ADDENDUM NO. 1
The Jefferson Project Sculpture Park and Garden

YOU ARE HEREBY ADVISED THAT the Contract Documents for the above referenced Project are revised in the following particulars:

THE JEFFERSON PROJECT
 1113 N JEFFERSON
 BAY CITY, MI 48708

CLEAN LINE COMMERCIAL GRADE LANDSCAPE EDGING
PLANTING BED EDGING DETAIL - STONE AND TURF

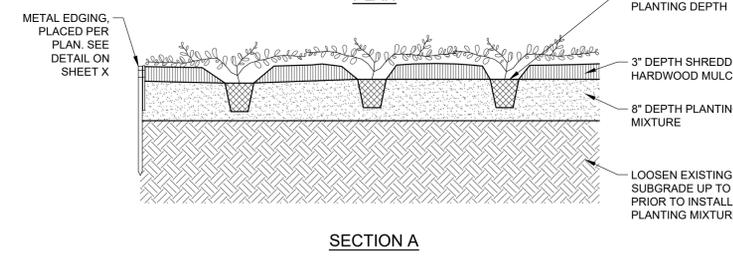
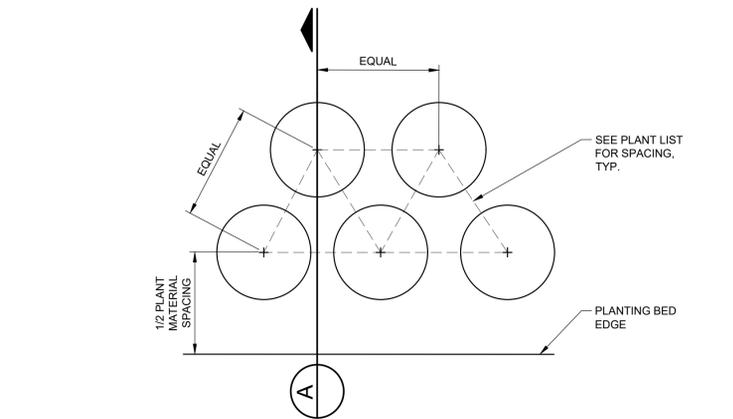
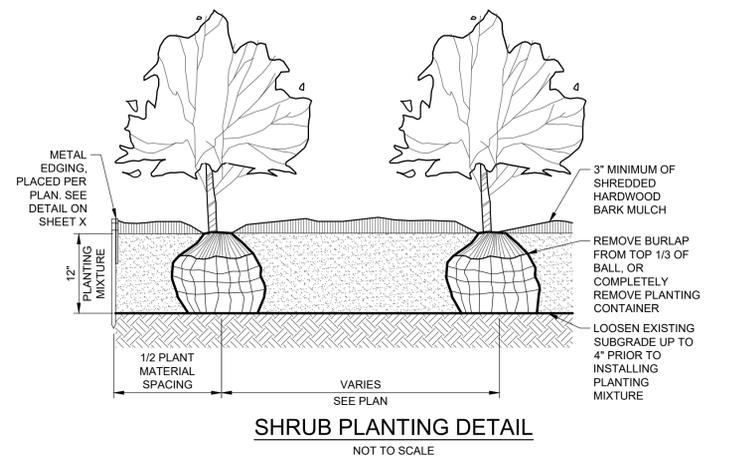
Plan Sheet L-2.0	Permaloc Cleanline Commerical Grade Landscape Edging detail added as approved equal for Corten Steel Edging
Plan Sheet E-3.0	Added separate conduit for future 3 phase connection to existing building
Plan Sheet E-3.0	Added wiring to light shown on plan
Plan Sheet C-8.0	Updated 4" Concrete Sidewalk with Crushed Limestone Edge to read "Luminii Kurba Large, Static White" and shown on both sides of sidewalk.
Plan Sheet C-8.0	Callout on 4" Concrete Sidewalk with Crushed Limestone Edge detail updated to "1" x 4" PVC, attached mechanically to concrete @ 30" O.C. max
Plan Sheet C-8.0	Paver colors added to Typical Paver Labyrinth Installation Cross Section detail. Typically 4"-6" Compacted changed to 6" Compacted.
Plan Sheet C-8.0	Crushed Limestone size (1/2")
Plan Sheet C-8.1	Added Brick Paver Inlay detail
Plan Sheet C-8.5	Paver clarification added to Amphitheater Seat wall Detail

PERMALOC CLEANLINE ALUMINUM EDGING
TOP OF EDGING TO BE MAXIMUM OF 1/2" (12.7 MM) ABOVE SURFACE MATERIAL
BED MEDIA OR AGGREGATE

- 8'-0" (2.44 M) SECTIONS TO INCLUDE (3) 12" (305 MM) ALUMINUM STAKES.
- 16'-0" (4.88 M) SECTIONS TO INCLUDE (5) 12" (305 MM) ALUMINUM STAKES.
- CORNERS - CUT BASE EDGING UP HALFWAY AND FOR A CONTINUOUS CORNER.
- PERMALOC CLEANLINE AS MANUFACTURED BY PERMALOC CORPORATION.

TYPICAL PAVER LABYRINTH INSTALLATION CROSS-SECTION

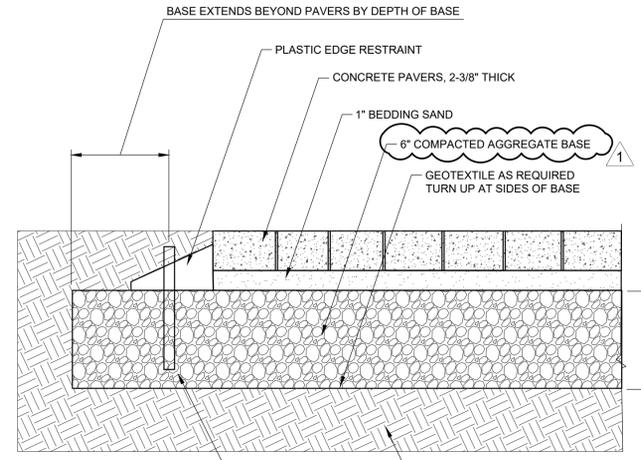
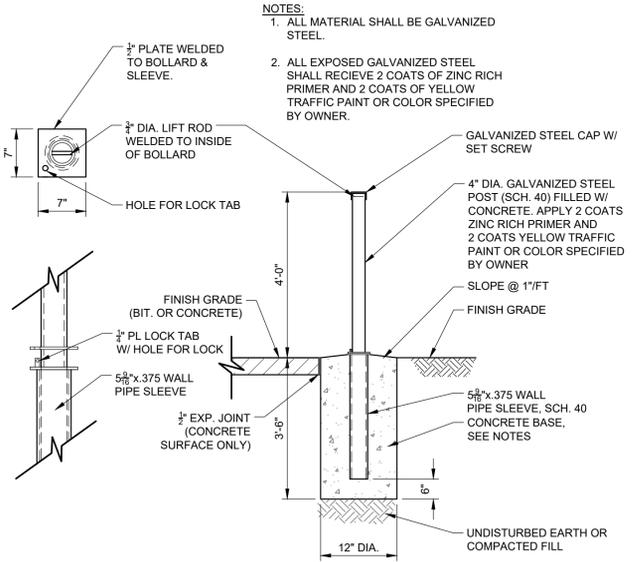
2. **Q - Labyrinth color options, for the pathway and the lines.**
A - See description of change in table above

NOTE:
1. WWW.LABYRINTHCOMPANY.COM
2. COLOR TO BE GRANITE GRAY FIELD WITH CHARCOAL LINES

BRICK PAVER INLAY
NOT TO SCALE

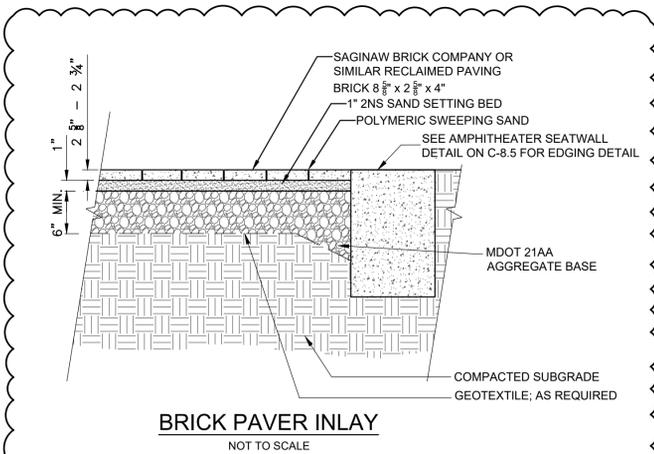
3. **Q - What type of pavers will the reclaimed pavers be?**
A - See description of change in table above

4. **Q - What type of base will be needed or provided under the reclaimed paver area?**
A - See description of change in table above
